HISTORIC AND DESIGN REVIEW COMMISSION

HDRC CASE NO: 2017-217
ADDRESS: 1111 E CROCKETT ST
LEGAL DESCRIPTION: NCB 578 BLK D LOT W32.83 FT OF E 65.66 FT OF 5 ARB A7 AT 1111
ZONING: RM-4 H
CITY COUNCIL DIST.: 2
DISTRICT: Dignowity Hill Historic District
APPLICANT: Felix Ziga/Studio Ziga
OWNER: Henneke Financial Group, LLC
TYPE OF WORK: Construction of two, single family structures
REQUEST:

The applicant is requesting conceptual approval to construct a two story residential structure on the vacant lot at 1111 E Crockett.

schematic design: floor plans - front elevation

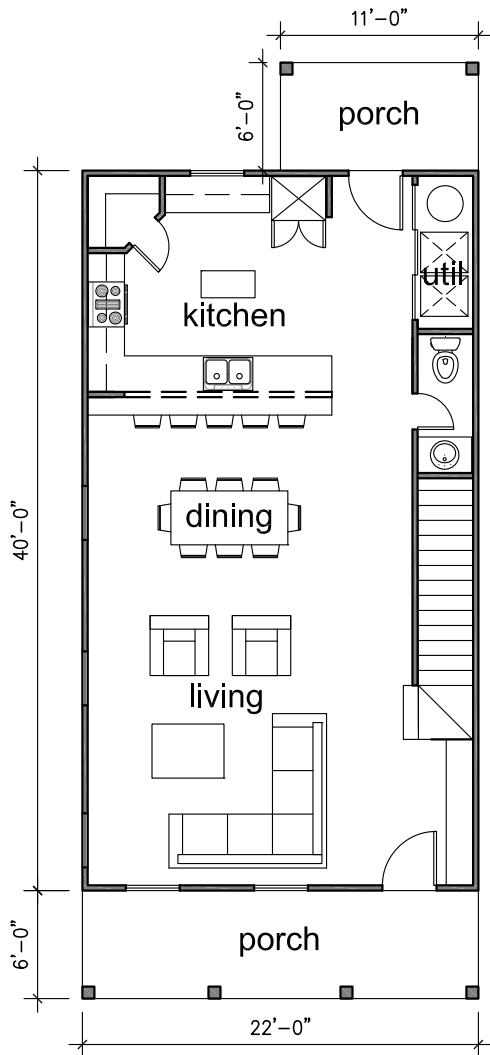
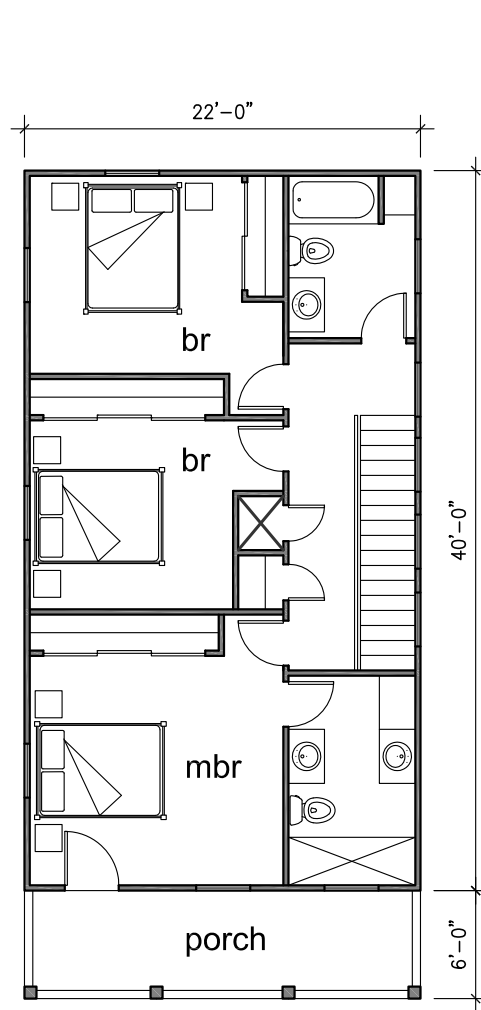
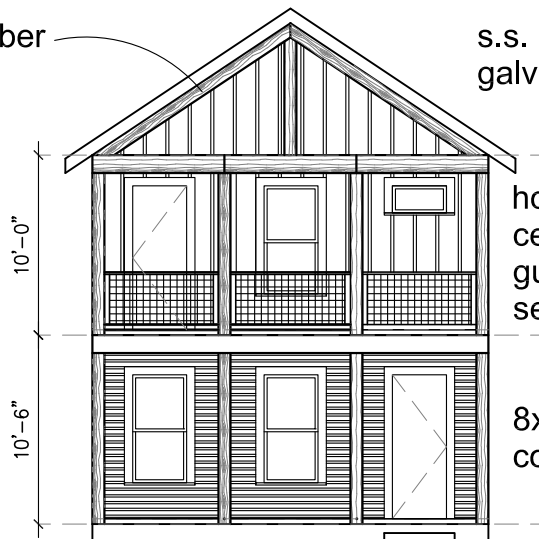
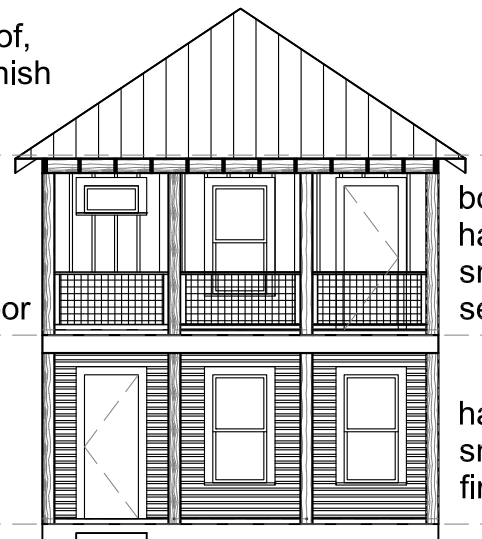
- j. **WINDOW & DOOR OPENINGS** – Per the Guidelines for New Construction 2.C.i., window and door openings with similar proportions of wall to window space as typical with nearby historic facades should be incorporated into new construction. On the front façade, the applicant has proposed window openings that are sized to be similar to those found historically in the district with the exception of the window in the second floor bathroom. On the west and north elevations, the applicant has proposed window openings that are sized to be similar to those found throughout the district. The east elevation is generally void of fenestration and is not consistent with the Guidelines. Staff recommends the applicant introduce fenestration to the west façade that is comparable to that found on the other proposed facades, introduce an additional window to the rear façade's second floor and introduce a window on the front façade that is at least half of the height of the other proposed window openings on the front façade.

- l. **MATERIALS** – Regarding materials, the applicant has proposed first floor materials to include horizontally oriented Hardi siding, a second floor of board and batten Hardi siding, eight inch square cedar columns, hog wire and cedar guardrails, cedar timber trusses and a standing seam metal roof. The applicant has noted that the proposed Hardi siding will feature a smooth finish. Staff finds that the horizontally oriented Hardi siding should feature an exposure of four inches, that the board and batten siding feature boards that are twelve (12) inches wide with battens that are 1 – ½" wide, that the standing seam metal roof feature panels that are 18 to 21 inches wide, seams are 1 to 2 inches in height, a crimped ridge seam or low profile ridge cap and a standard galvalume finish. A large profiled ridge cap shall not be used.

- o. **COLUMN DESIGN** – The applicant has proposed eight in square cedar columns. Given the proposed height and porch massing, staff finds the proposed columns to feature an appropriate size; however, each column should feature both a capital and base.

- iii. That the applicant incorporate window openings that are consistent with the Guidelines as noted in finding l.
- iv. That the applicant install wood windows that are to include traditional dimensions and profiles, be recessed within the window frame, feature traditional materials or appearance and feature traditional trim and sill details as noted in finding m.

- v. That the applicant provide a column detail noting the installation of a capital and base as noted in finding o.
- vi. That the applicant screen all mechanical equipment as noted in finding p.

schematic design: site plan

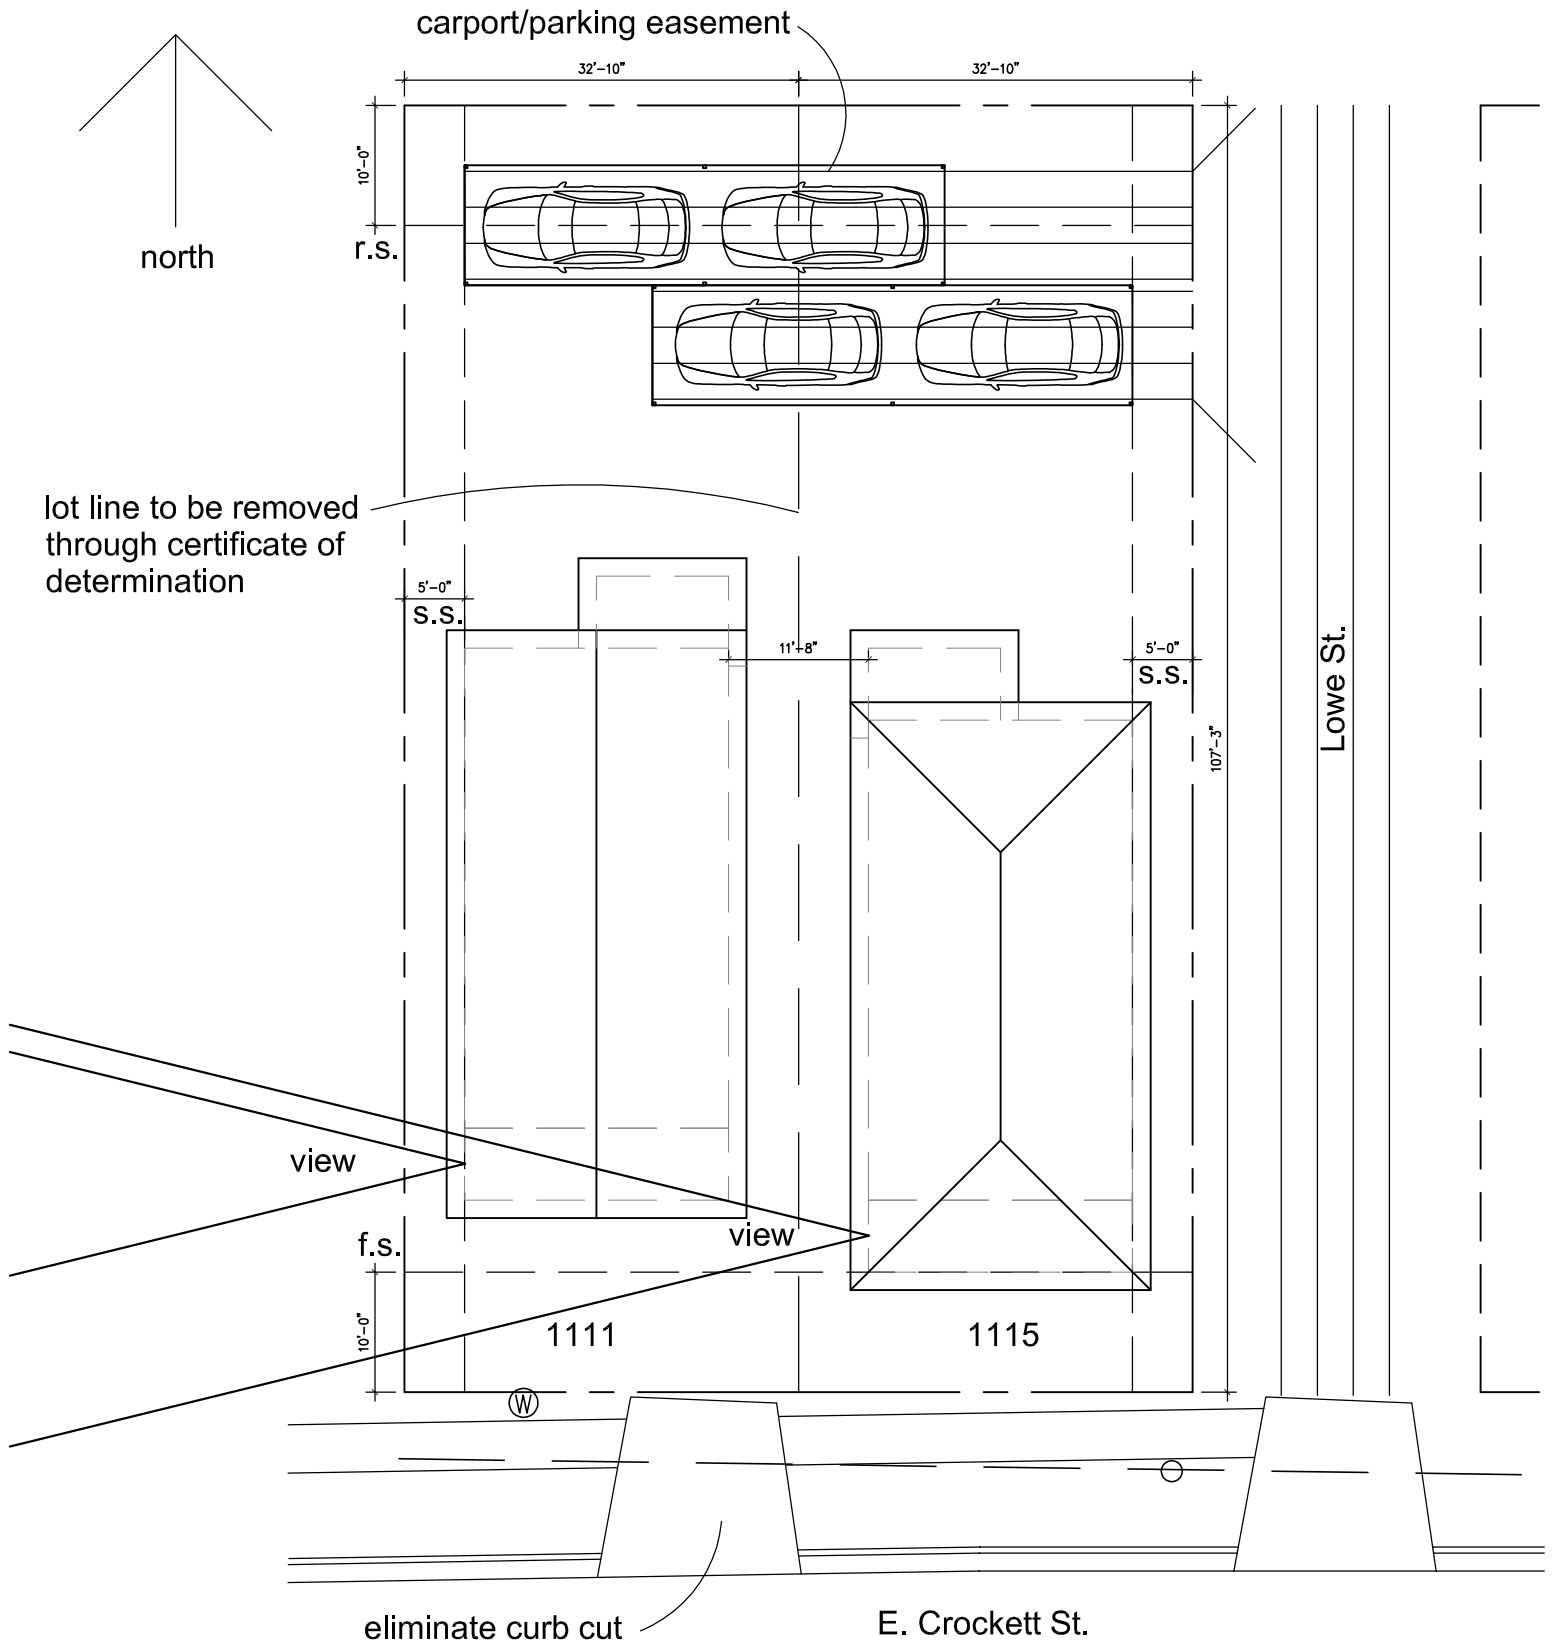
- e. **SETBACKS & ORIENTATION** – According to the Guidelines for New Construction, the front facades of new buildings are to align with front facades of adjacent buildings where a consistent setback has been established along the street frontage. Additionally, the orientation of new construction should be consistent with the historic examples found on the block. The applicant has proposed a setback of approximately twenty (20) feet. The structures to the immediate west feature a setback of approximately twenty-five (25) feet. Staff recommends the applicant install a setback that is consistent with the historic setbacks found on the block.

- q. **DRIVEWAY** – Adjacent to the proposed new construction, a public right of way, Lowe Street exists. Currently, this street is unpaved and a residential driveway approach exists where it meets E Crockett Street. The applicant has proposed to install a ribbon strip driveway in the public right of way to facilitate automobile parking at the rear of this lot and an adjacent lot which will also feature new construction. Staff finds the proposed rear parking location appropriate; however, the applicant shall coordinate with the City of San Antonio, Transportation and Capital Improvements Department to determine if the proposed installation of a ribbon strip driveway in the public right of way is appropriate and allowed.

- r. **SIDEWALK** – At this time, the applicant has not proposed a front yard sidewalk to lead from the front porch to the public right of way. Front yard sidewalks are character defining features of historic neighborhoods. Staff recommends the applicant incorporate a front yard sidewalk in to the proposed new construction.

- s. **CARPORT** – At the rear of the lot, the applicant has proposed to construct a carport to feature covered parking for two automobiles. The structure will feature forty (40) feet in length and ten (10) feet in width. Staff finds the general size and location of the proposed carports appropriate; however, the applicant should provide additional information regarding materials and details.

- vii. That the applicant incorporate a front yard sidewalk as noted in finding r.
- viii. That the applicant provide a landscaping plan noting landscaping materials as noted in finding t.

- ix. That the applicant provide additional information regarding the proposed carport's materials as noted in finding s.

Setback Diagram

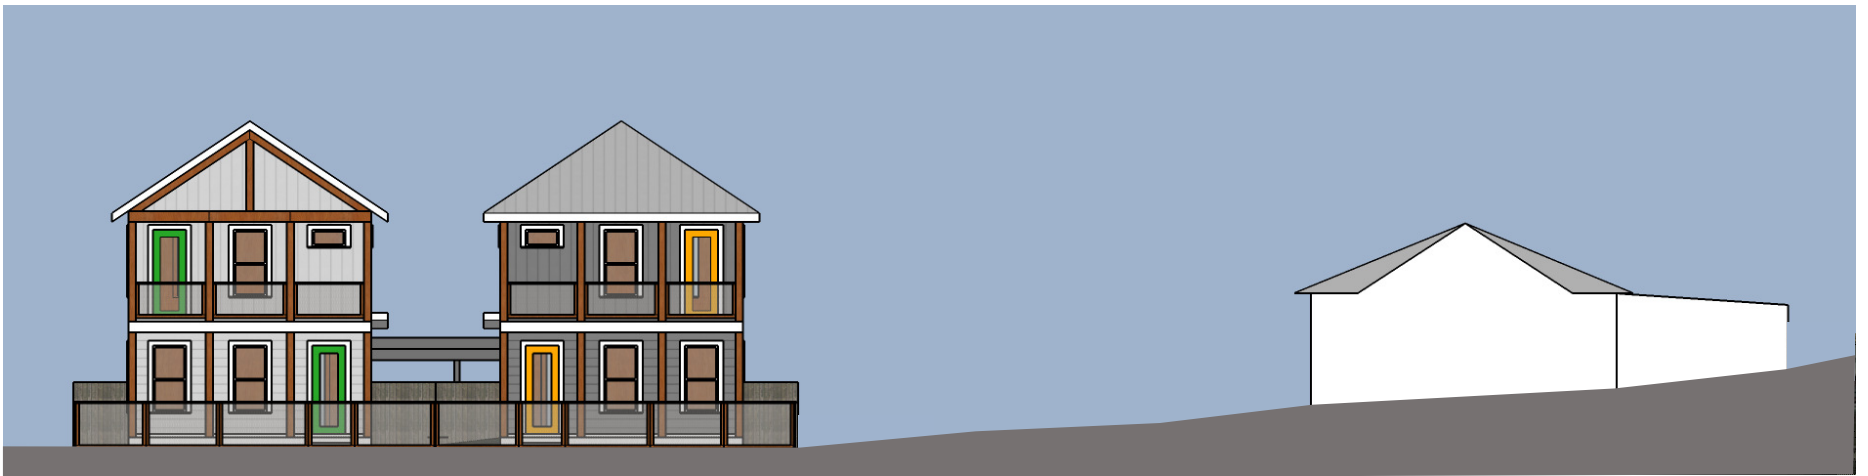
- h. **FOUNDATION & FLOOR HEIGHTS** – According to the Guidelines for New Construction 2.A.iii., foundation and floor height should be aligned within one (1) foot of neighboring structure's foundation and floor heights. Historic structures on this block feature foundation heights of approximately two to three feet. Staff finds that the applicant should incorporate a foundation height that is consistent with those found historically on this block.

Front setbacks on this block of E. Crockett St. are not consistent along either side of the street. Both proposed structures are at or behind the median front setback.

Due to the ground slope, foundation heights are not consistent throughout this block of E. Crockett St. The lowest measurement at the front entrance is at approximately 18in and the highest at approximately 30in. The majority of houses have a 24in height. The proposed design is elevated by 18in which is within one foot of the majority of houses on the block as recommended by the guidelines.
